Proposed Technical Specification Change

Surry Power Station

Units 1 and 2

**Safety Evaluation
Surry Power Station
Units 1 and 2**

Figure 1

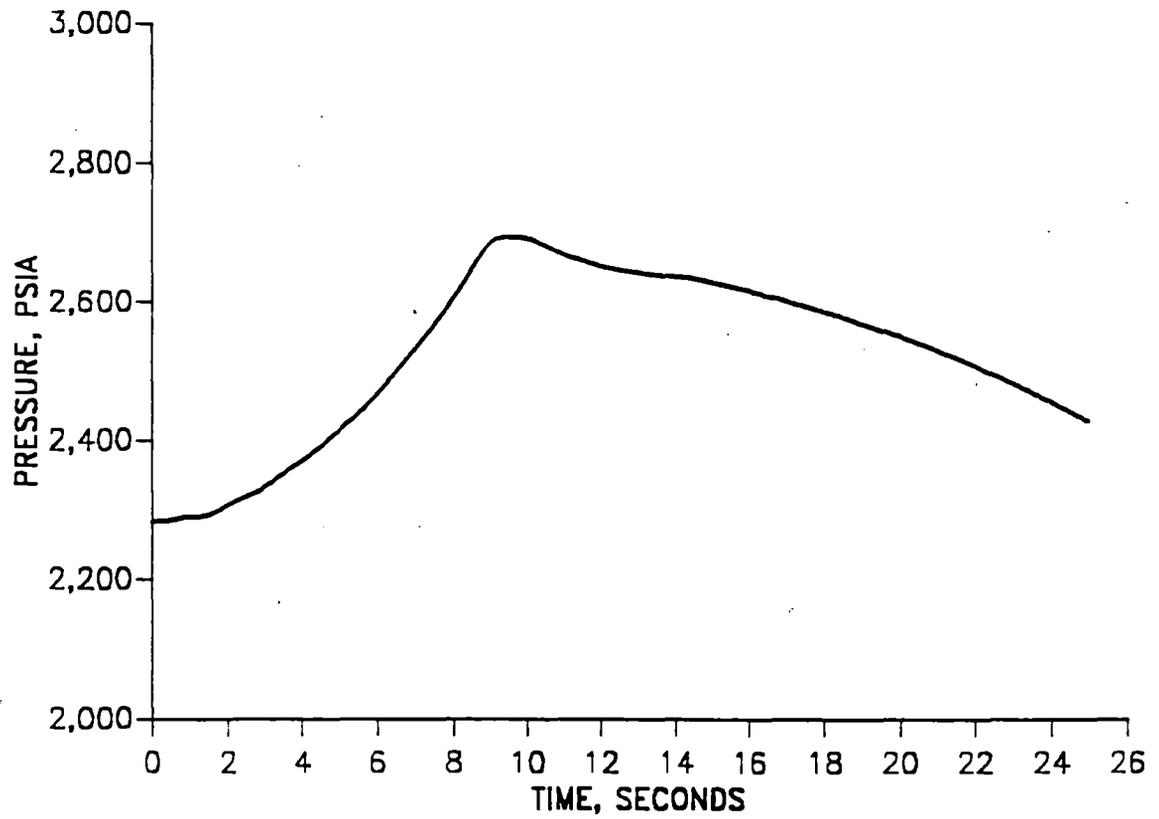
The maximum primary side (cold leg) pressure was determined to be 2694 psia, which is well below the overpressure safety limit (110% of design pressure) of 2750 psia. The maximum secondary side (steam generator) pressure was determined to be 1179 psia, which is well below the overpressure safety limit of 1210 psia.

Graphs of the primary and secondary side pressure transients may be seen in Figures 1 and 2.

Figure 3

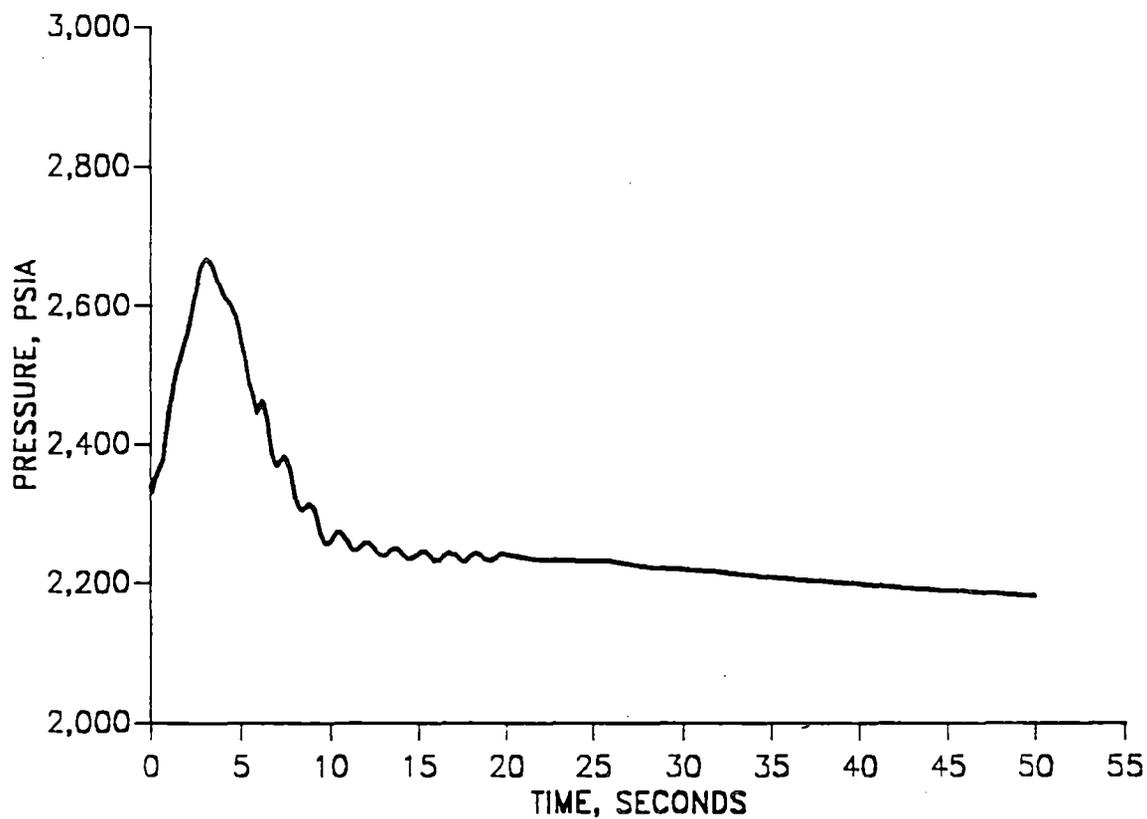
The RETRAN transient analysis of the Locked Rotor event with a 3% PSV setpoint tolerance rendered a peak primary (cold leg) pressure of 2667 psia and a peak secondary (steam generator) pressure of 1166 psia. These values are below the primary and secondary pressure safety limits of 2750 psia and 1210 psia, respectively.

Graphs of the primary and secondary side pressure transients may be seen in Figures 3 and 4.
